LEGAL ADVERTISEMENT PORTLAND PLANNING BOARD MEETING

AGENDA PORTLAND PLANNING BOARD MEETING

PLANNING BOARD REPORT PORTLAND, MAINE

Submitted to: Portland Planning Board: Public Hearing Date: June 14, 2016	Prepared by: Shukria Wiar, Planner Date: June 10, 2016
--	---

EXISTING
CONDITIONS PLAN

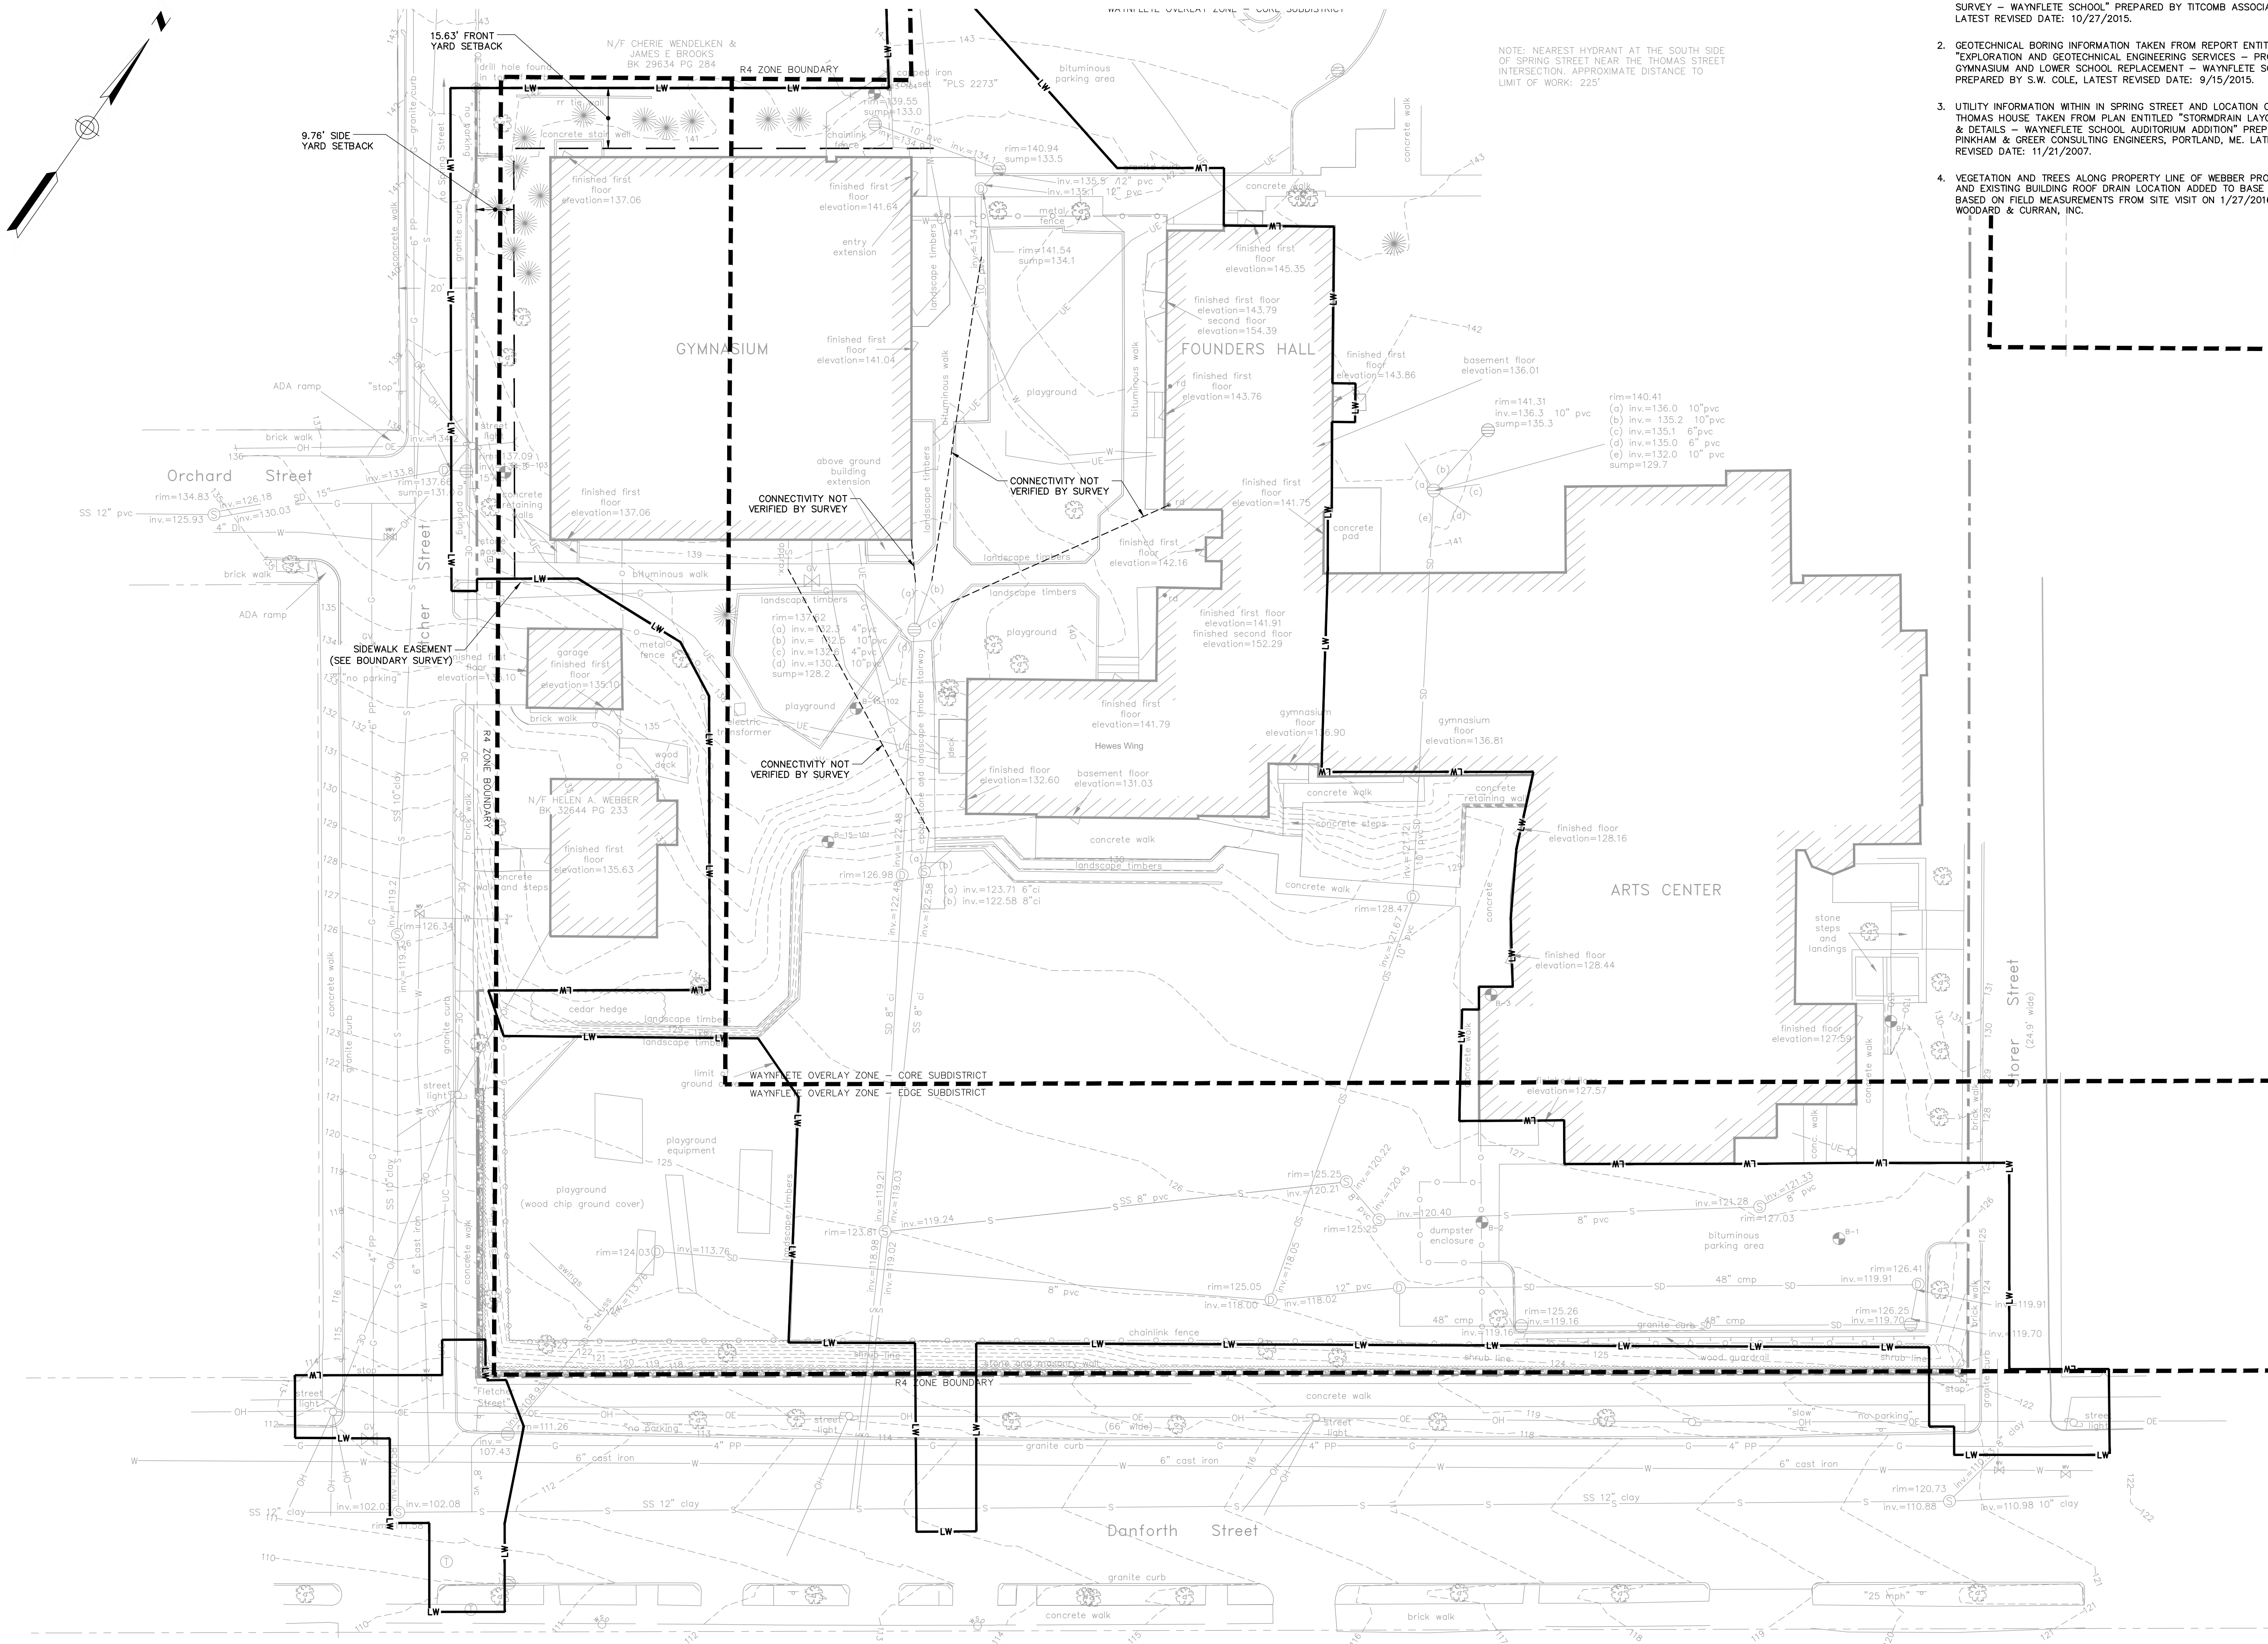
Reference to the Helen Webber easement has been added to the existing conditions plan sheet C-001. The easement (provided as part of a previous response to comments) does not define the specific bounds

ELEVATIONS

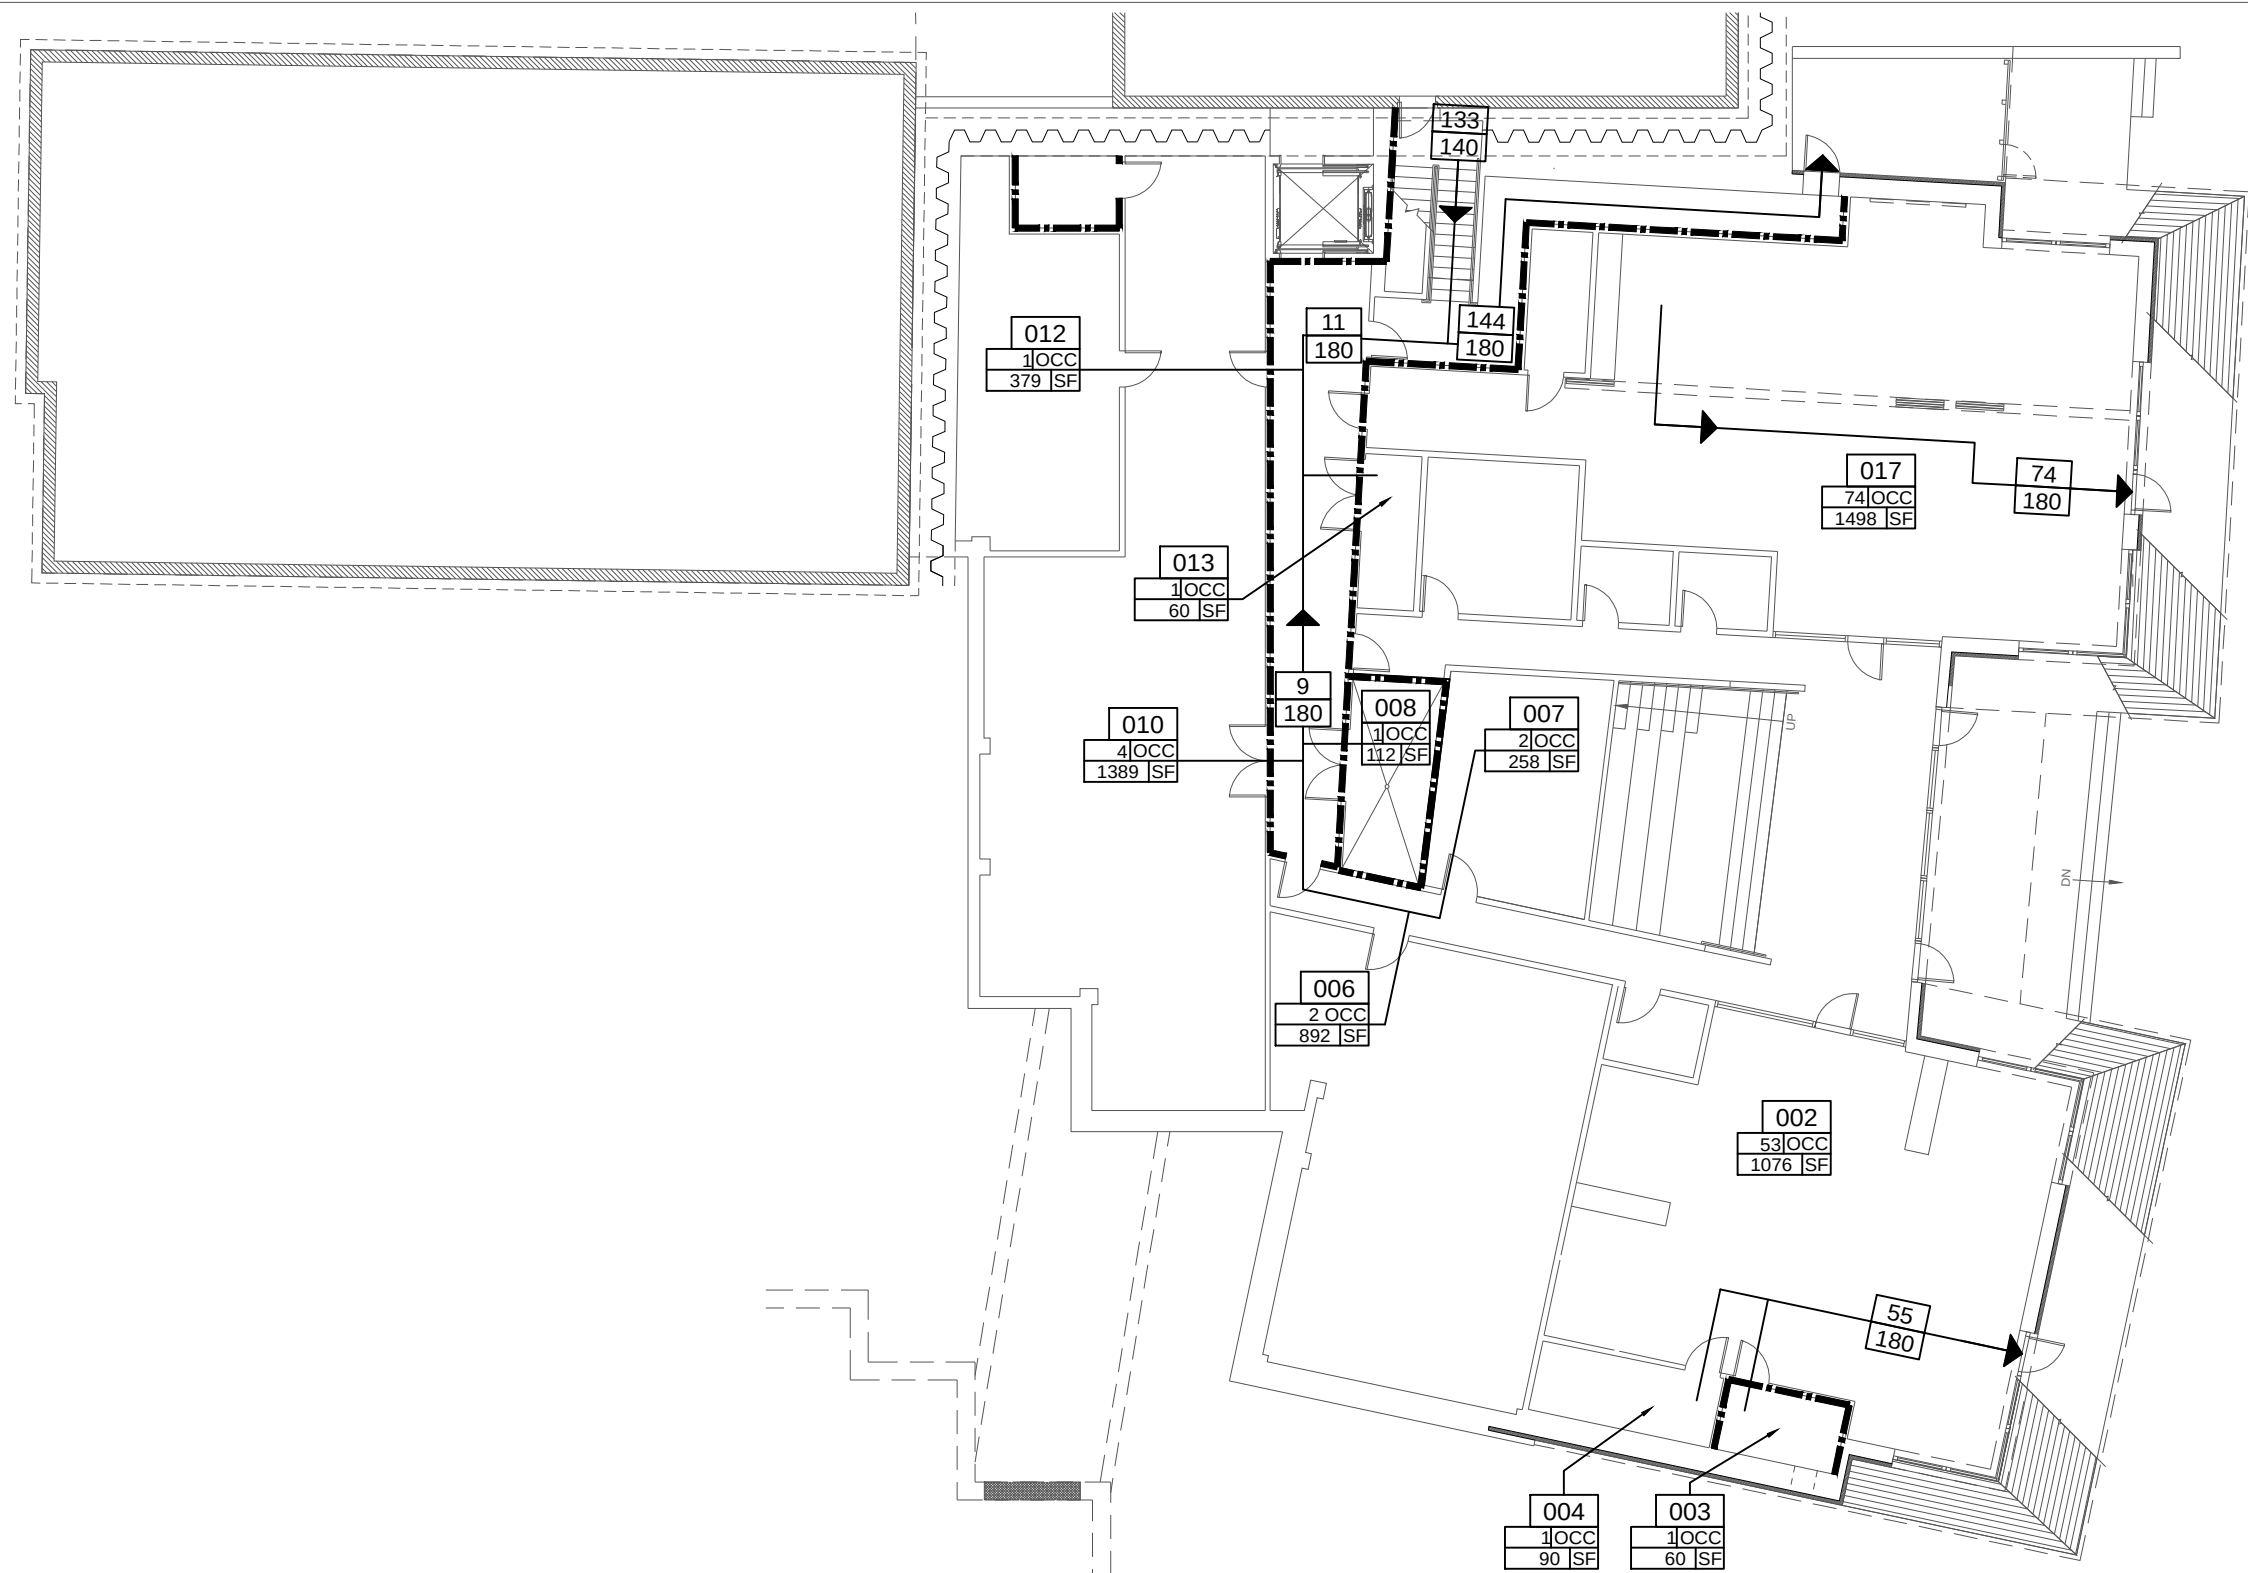
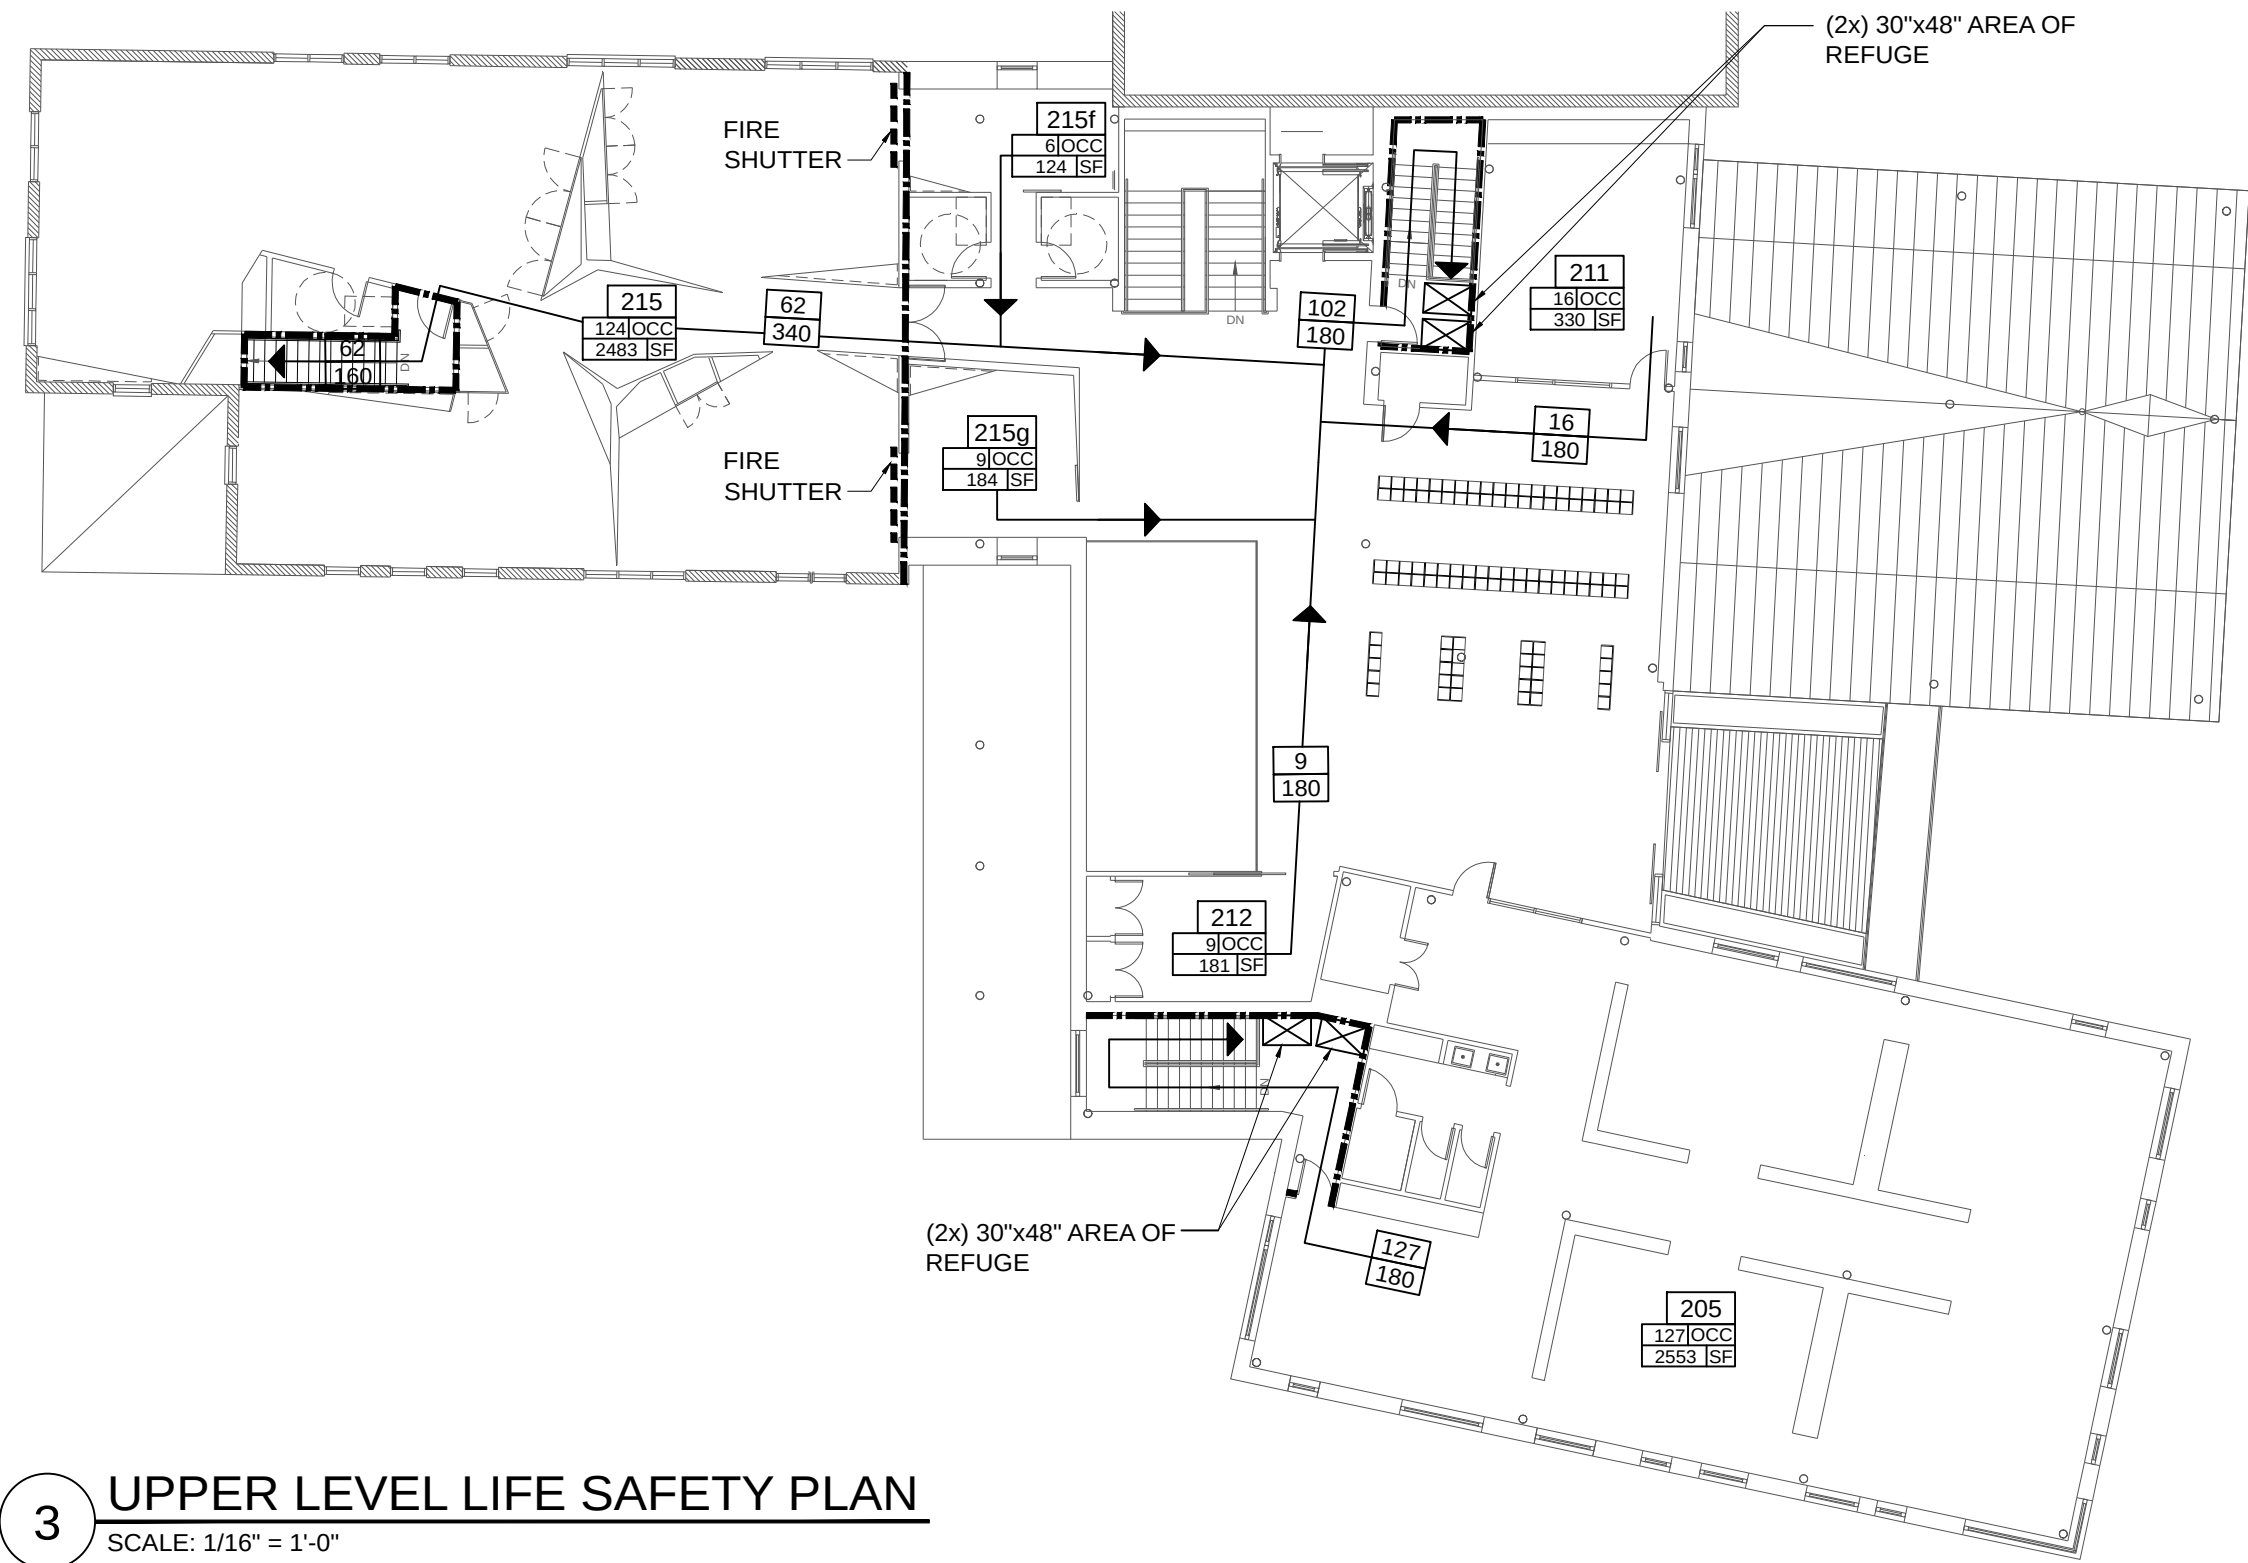
Scott Simons Architects has prepared the attached Figure 2 (Attachment 3) height calculation graphic (utilizing Sheet A201) for the lower school building.
